MAINE TURNPIKE AUTHORITY

ADDENDUM NO. 2

CONTRACT 2019.10

BRIDGE REPLACEMENT
WARREN AVENUE OVERPASS (MILE 49.0)

WARREN AVENUE OVERPASS
 BRIDGE REPLACEMENT
 MAINLINE
 TRAFFIC CONTROL PLAN PHASE 3B (1 OF 4)

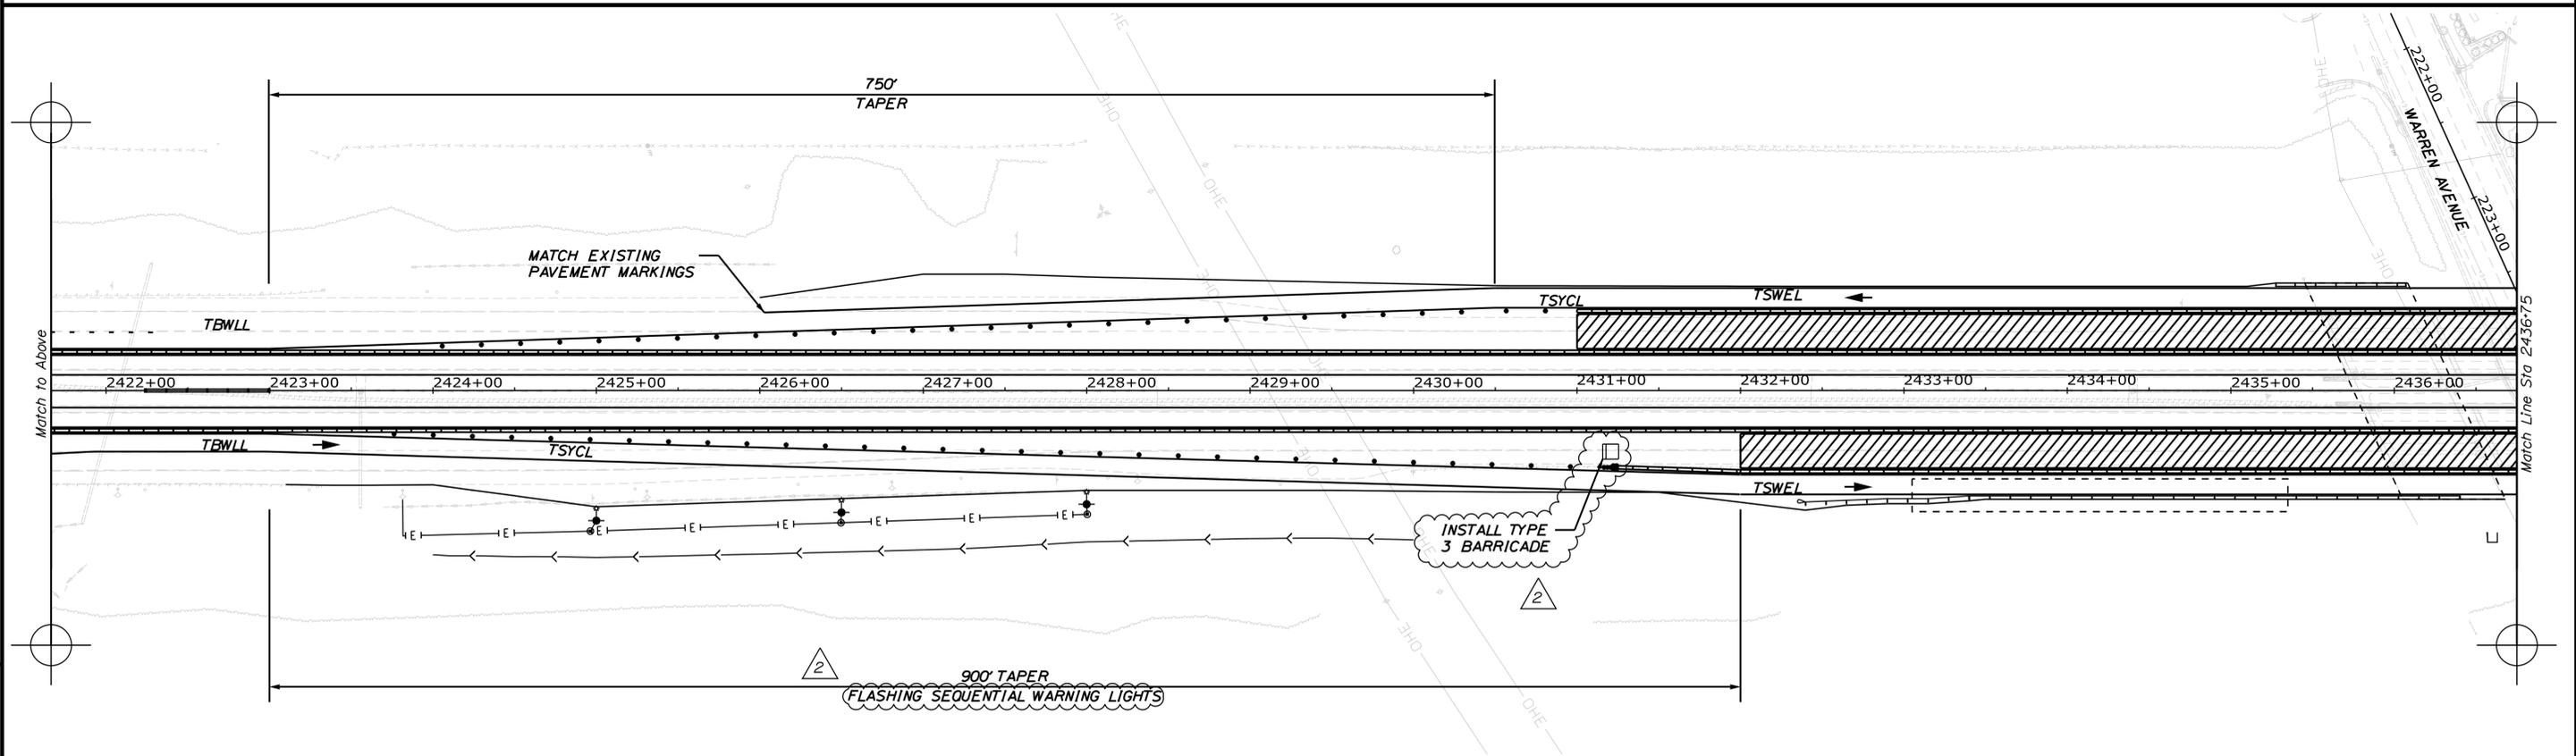
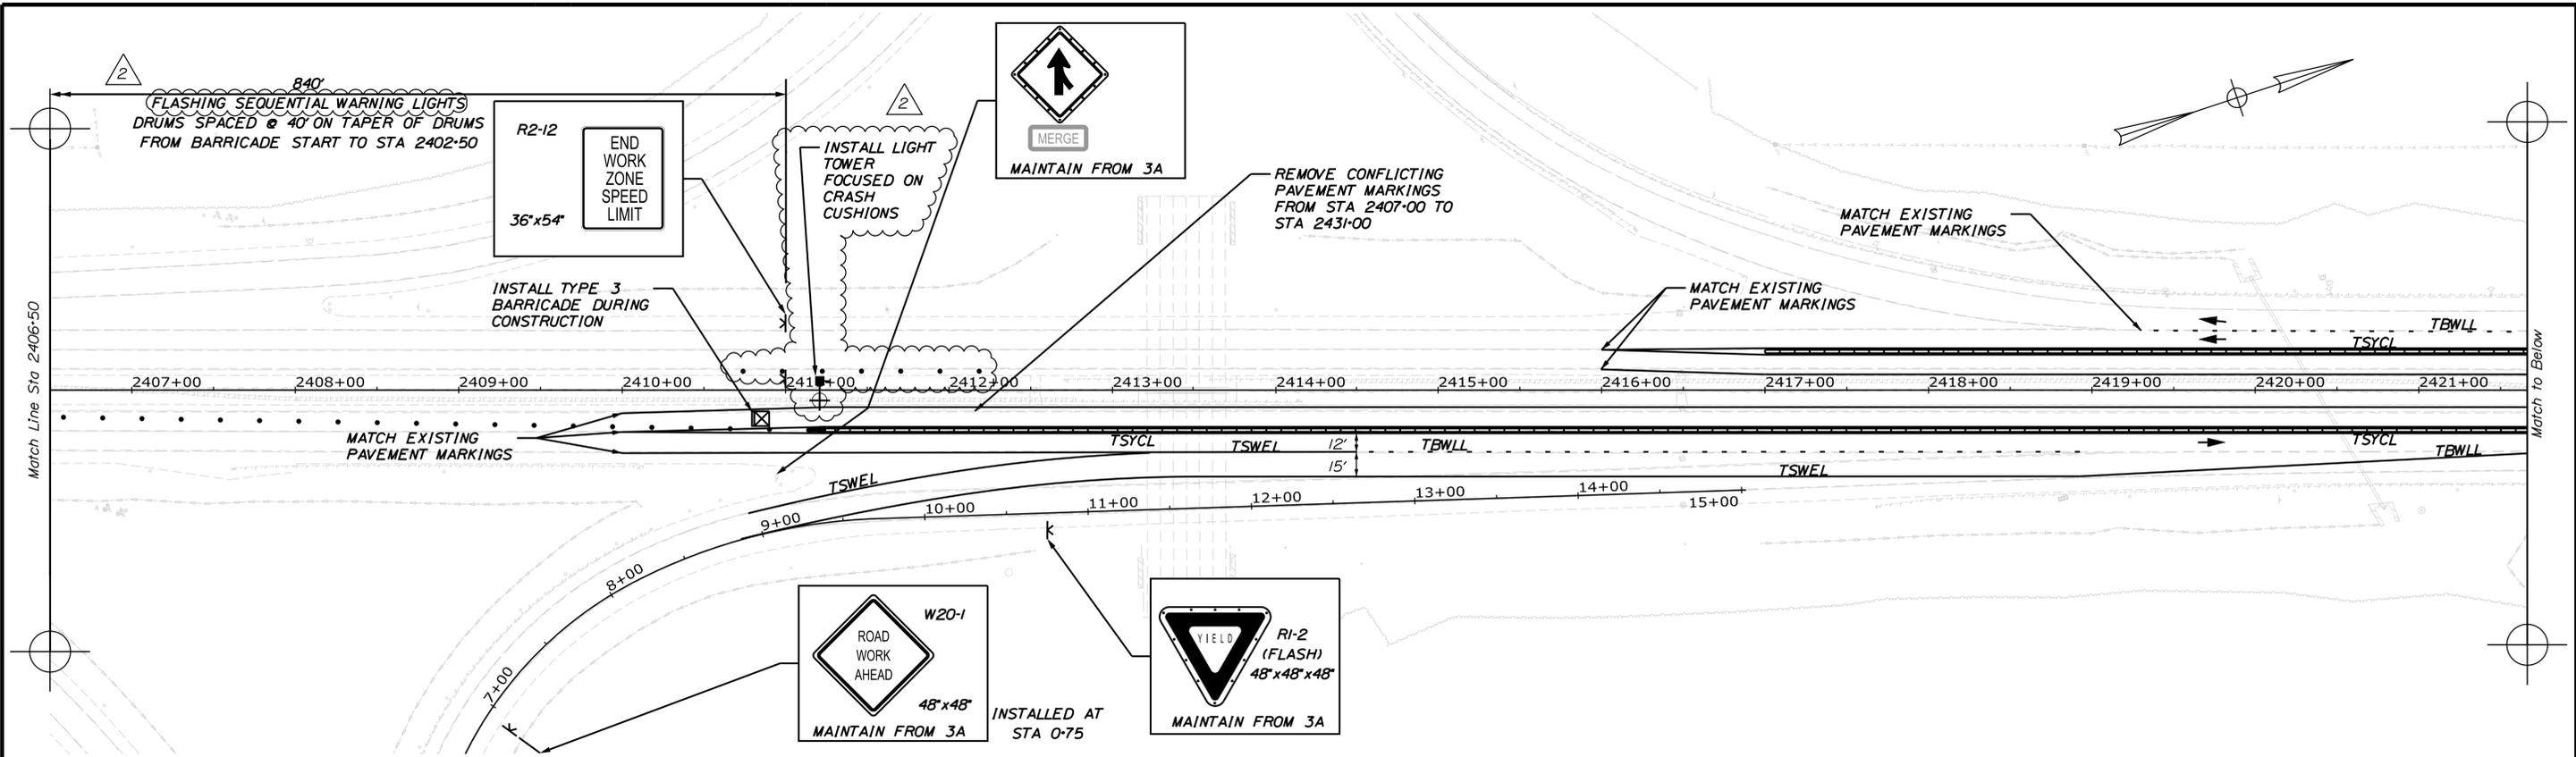
Question 5: If not for closure pour, what is the purpose for Phase 3B traffic control?

Response: *Phase 3B is intended to provide more work area and access for paving. See the notes on Contract Plan Sheet 77 for additional information and requirements.*

**WARREN AVENUE OVERPASS
BRIDGE REPLACEMENT
ABUTMENT NO. 1 PLAN
AND ELEVATION (1 OF 2)**

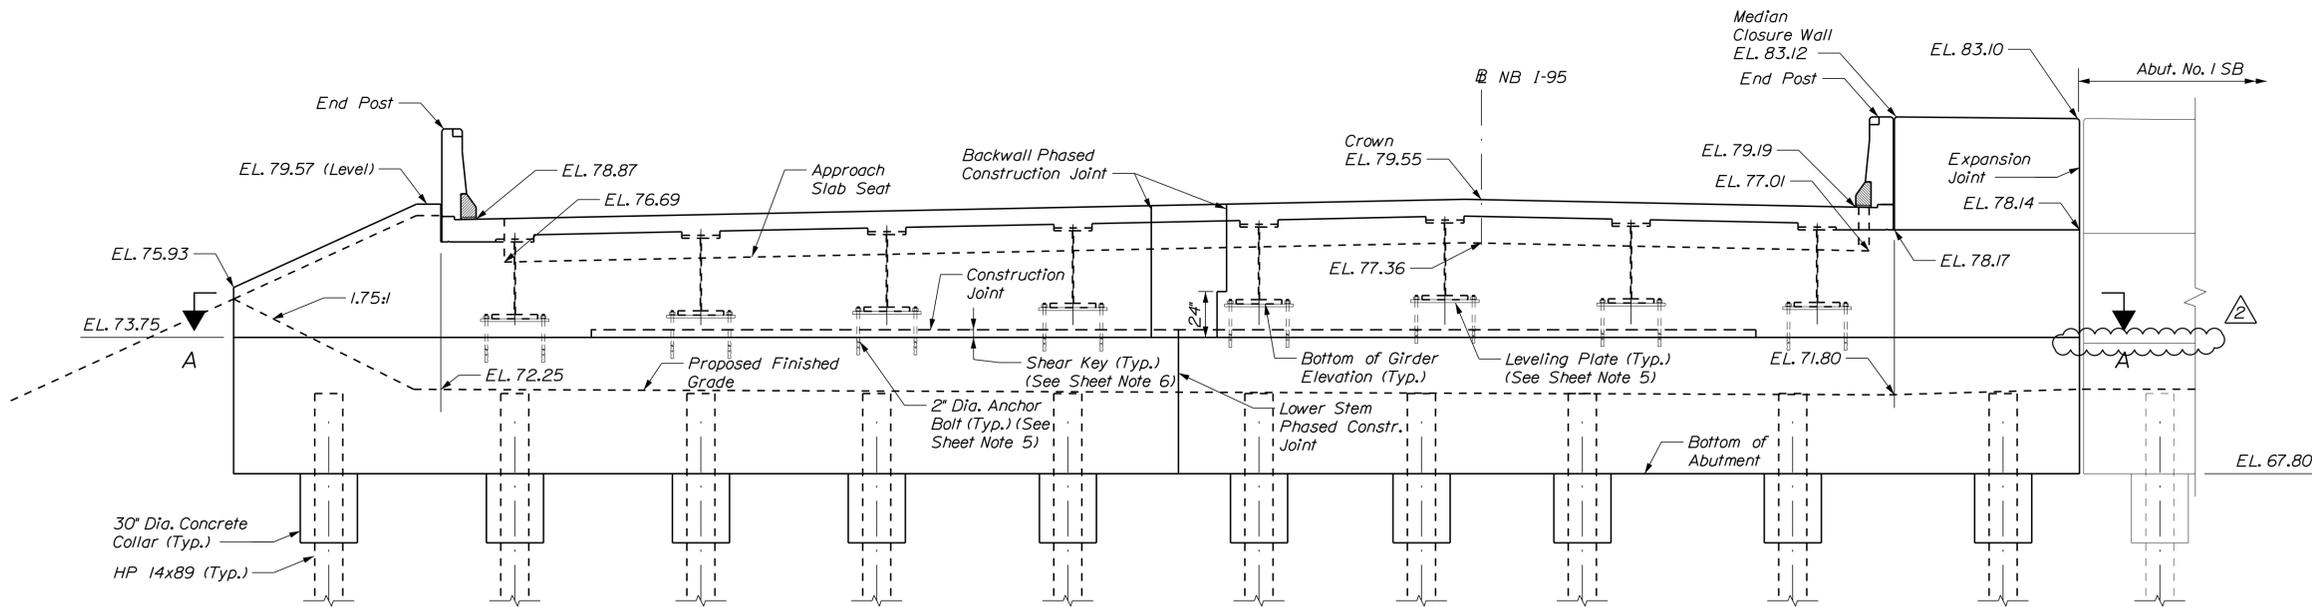
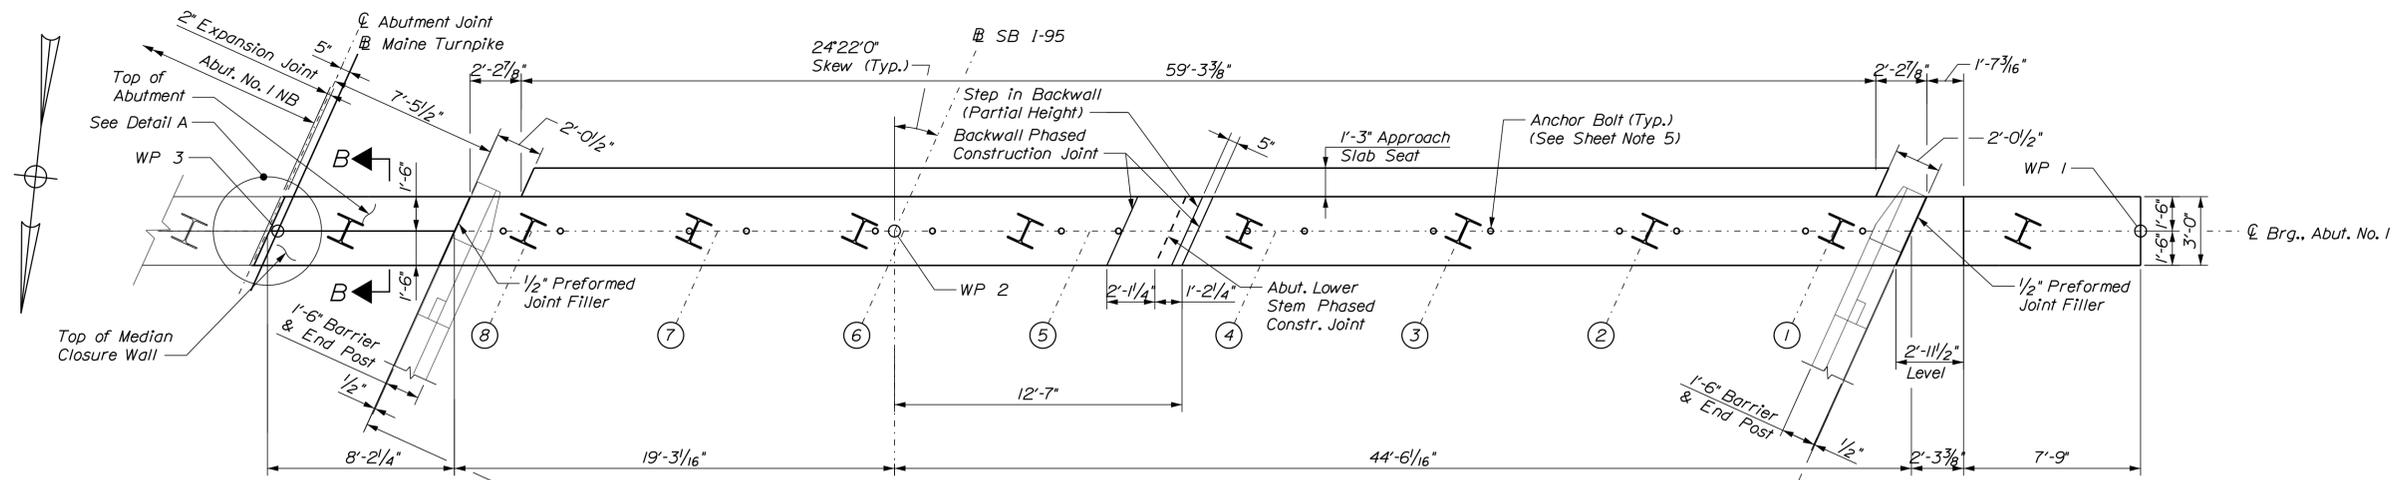
Question 15: Please reference Plan sheet 111 and 112 of 141. On sheet 111 the elevation of the top of the abutment stem is shown as 73.75. On plan sheet 122 the elevation of the top of the abutment stem is shown as 73.50. We do not see a step in the footing as drawn. Please advise.

Response: The elevations noted on the plans are correct. There was a minor discrepancy in the drawing. This has been clarified on the attached revised Contract Plan sheets 111 and 112.
